Grandview Reserve Master Development Drainage Plan

April 2020

Engineering Review

SKP-20-001

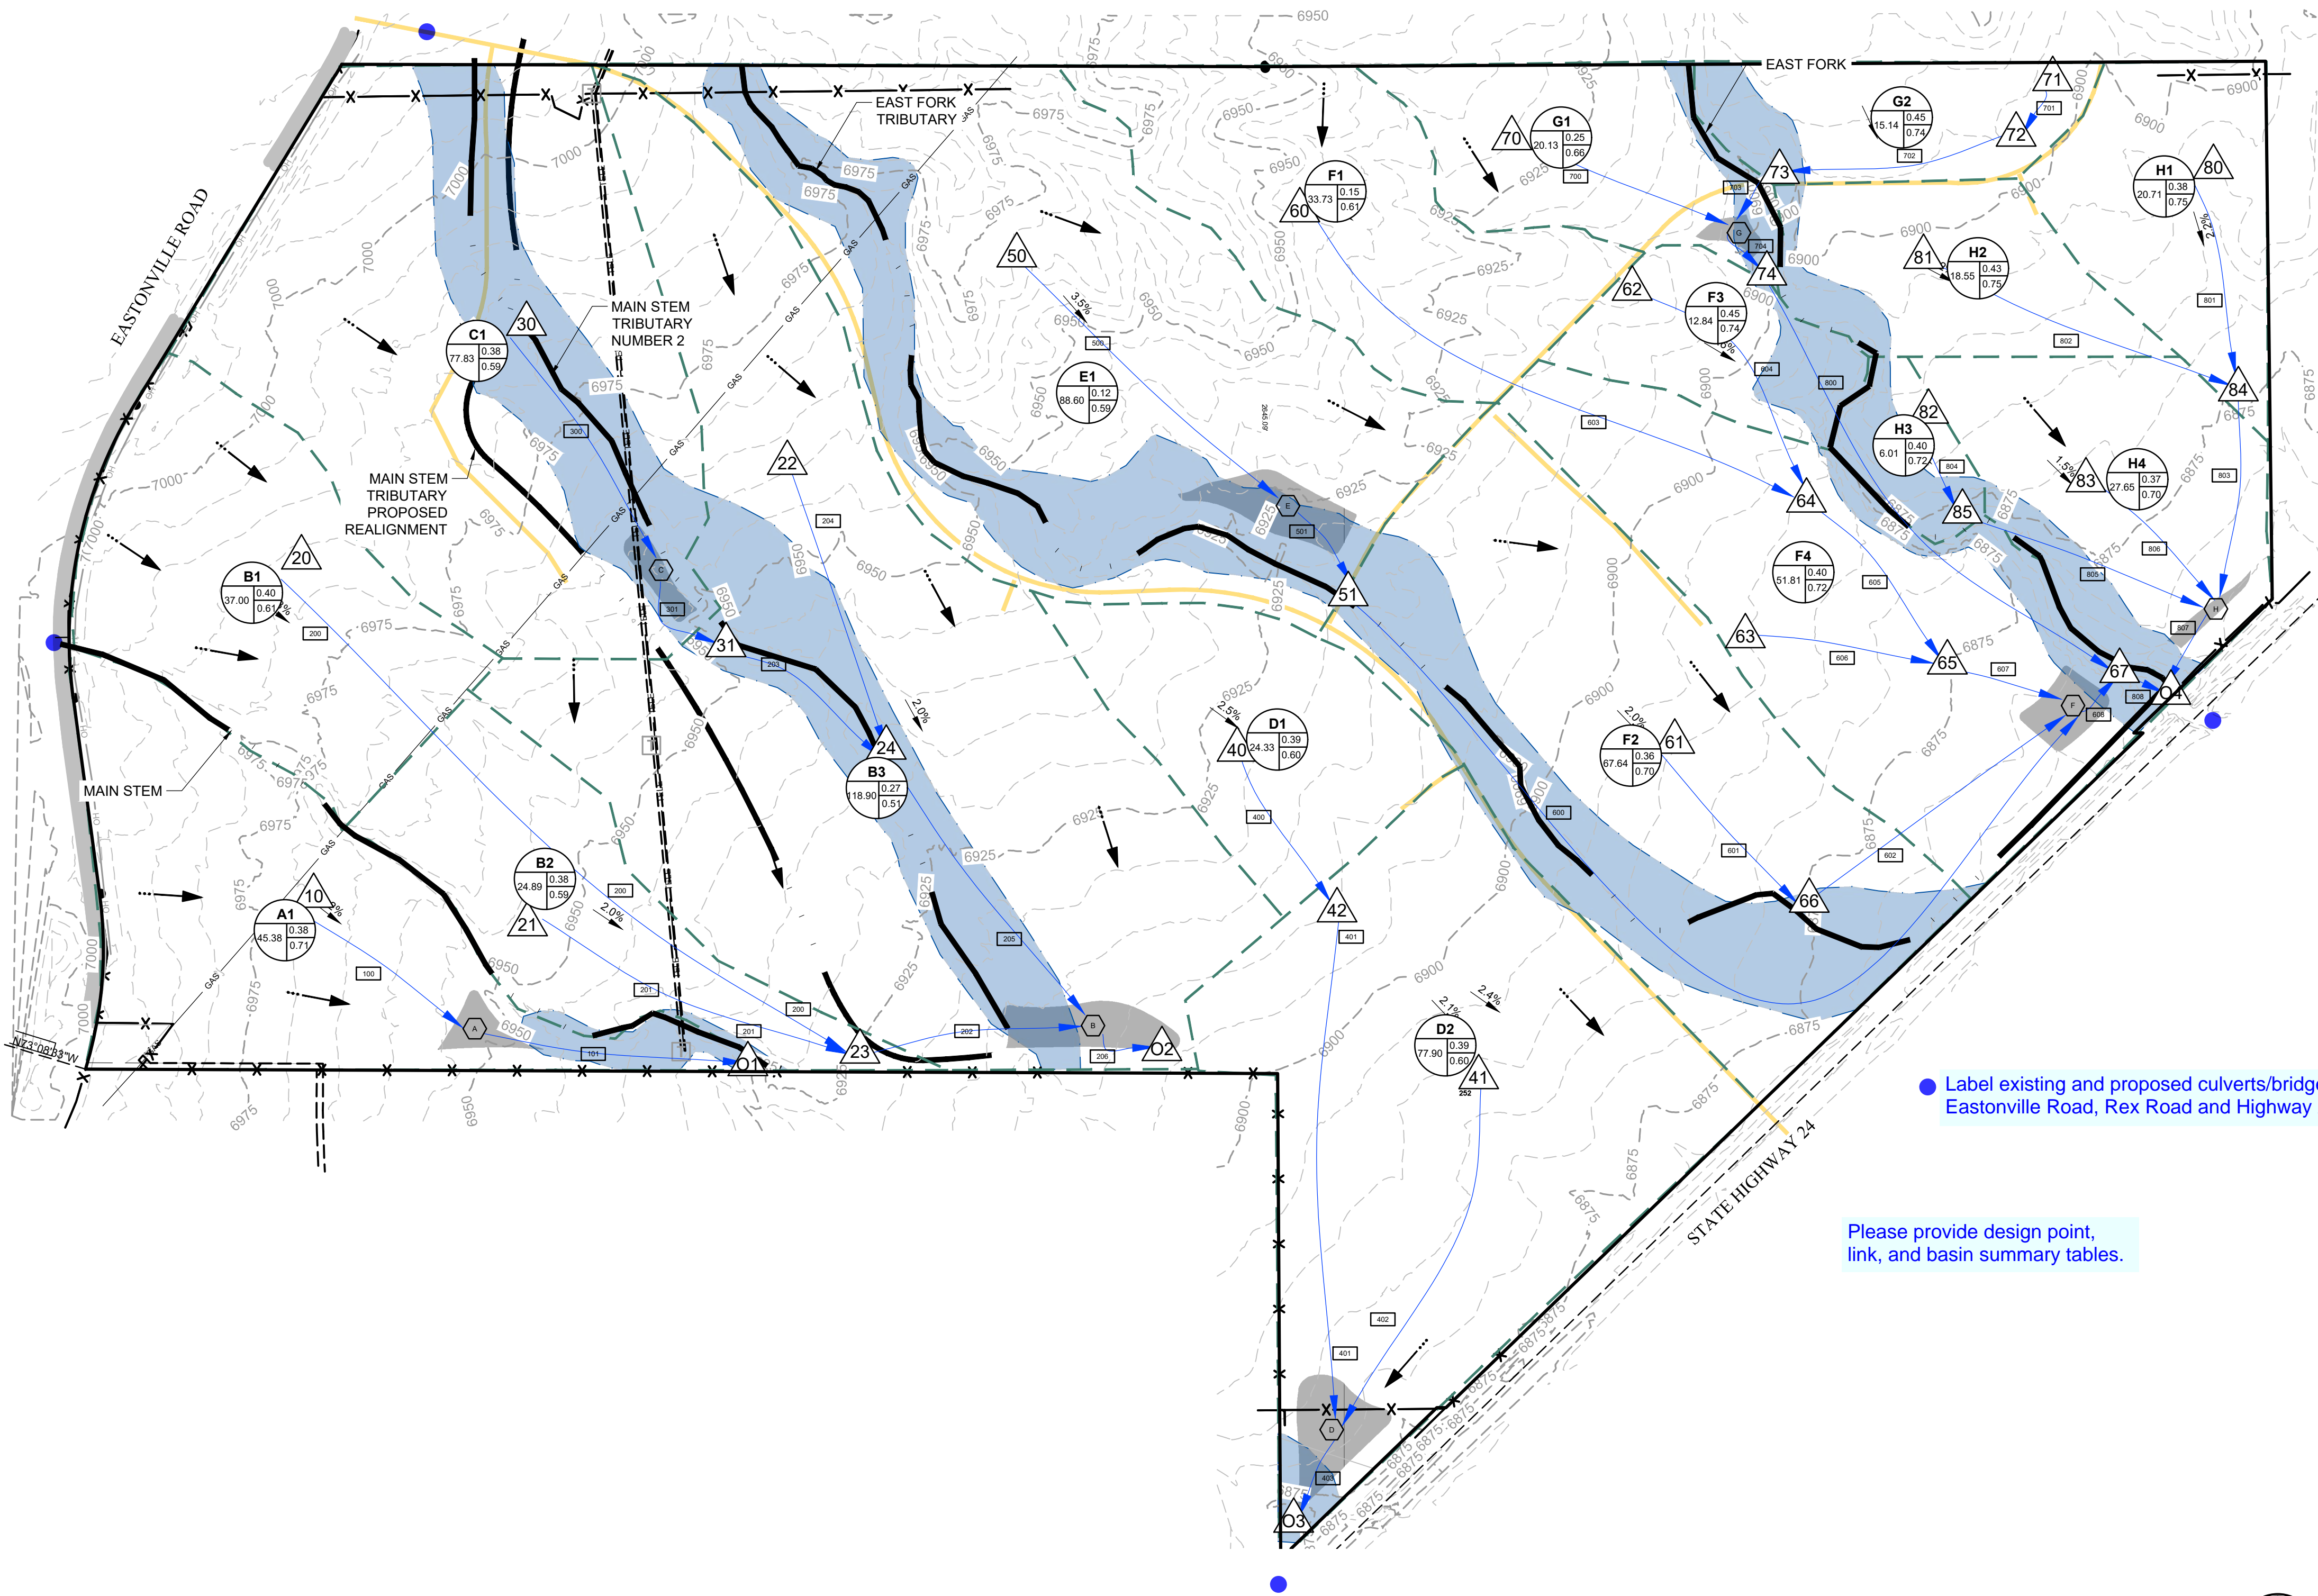
Please move pdf sheets 20-31 (drainage plans) to the end of the pdf.

Label the entire contributing basins.

Label existing and proposed culverts/bridges under Eastonville Road, Rex Road and Highway 24.

Please provide design point, link, and basin summary tables.
